Western Digital Corporation
 5863 Rue Ferrari
 San Jose, CA, 95138

To: T10 SAS Protocol Working Group
 Contact: Mark Evans
 Phone: 408.363.5257
 Email: mark.evans@wdc.com
 Date: [17 November 2008](#)

Subject: [SAS-2.1 / SPL](#), Low power transceiver options, phy states

Figure a — PS (phy layer) state machine - SAS phy power management states

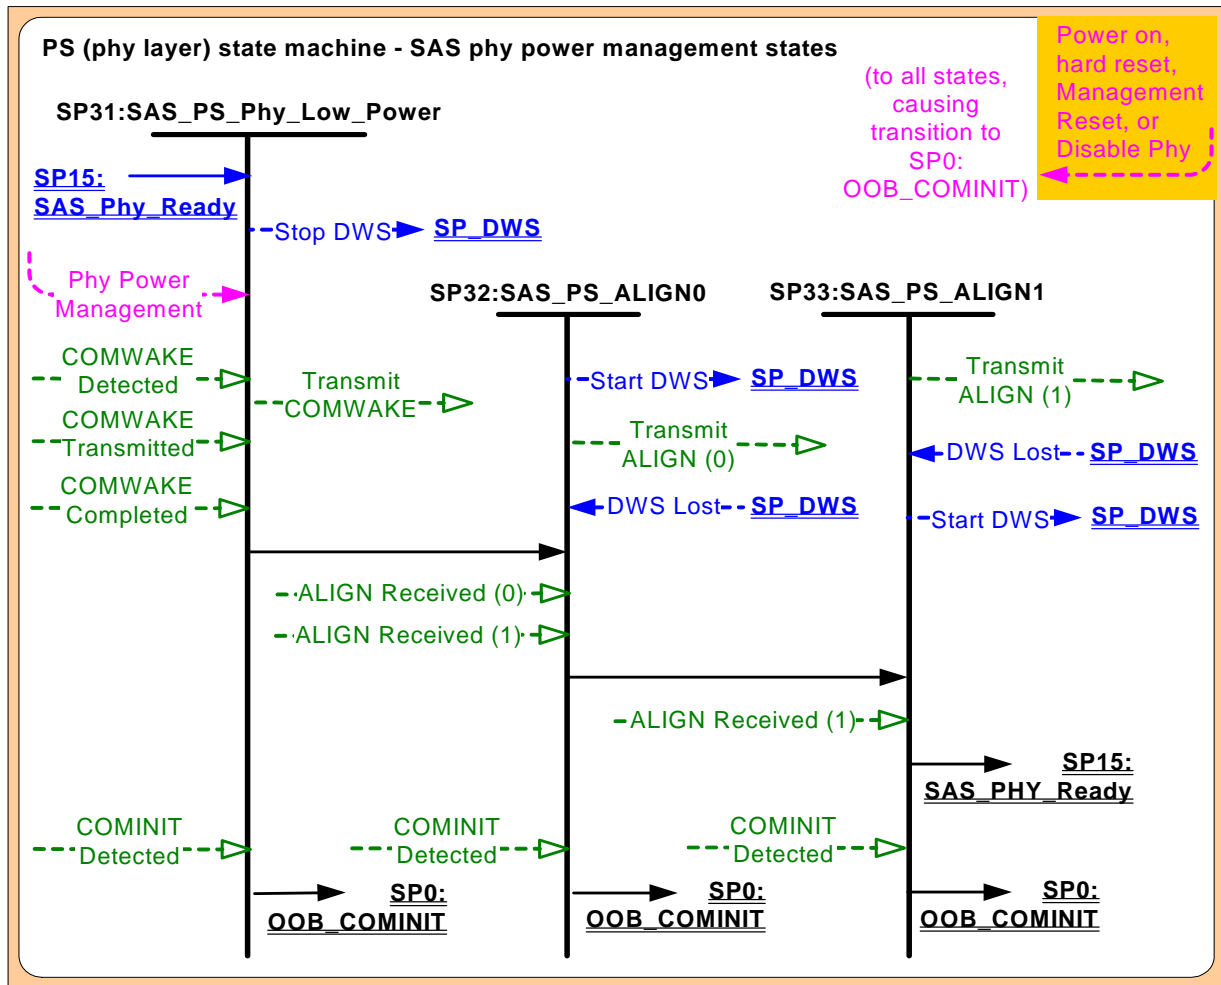
[Editor's note: this is a new clause with a new figure. The numbers of the clauses regarding SATA that follow increment by one (e.g., 6.8.5 becomes 6.8.6), and the numbers of all subsequent figures increment by one.]

Figure a shows the SAS phy power management states. These states are entered when a phy is requested to enter a low power condition (i.e., the SAS partial low power condition or the SAS slumber low power condition) and process the actions that return a phy from a low power condition to participating in an operational logical link.

These states are indicated by state names with a prefix of SAS_PS.
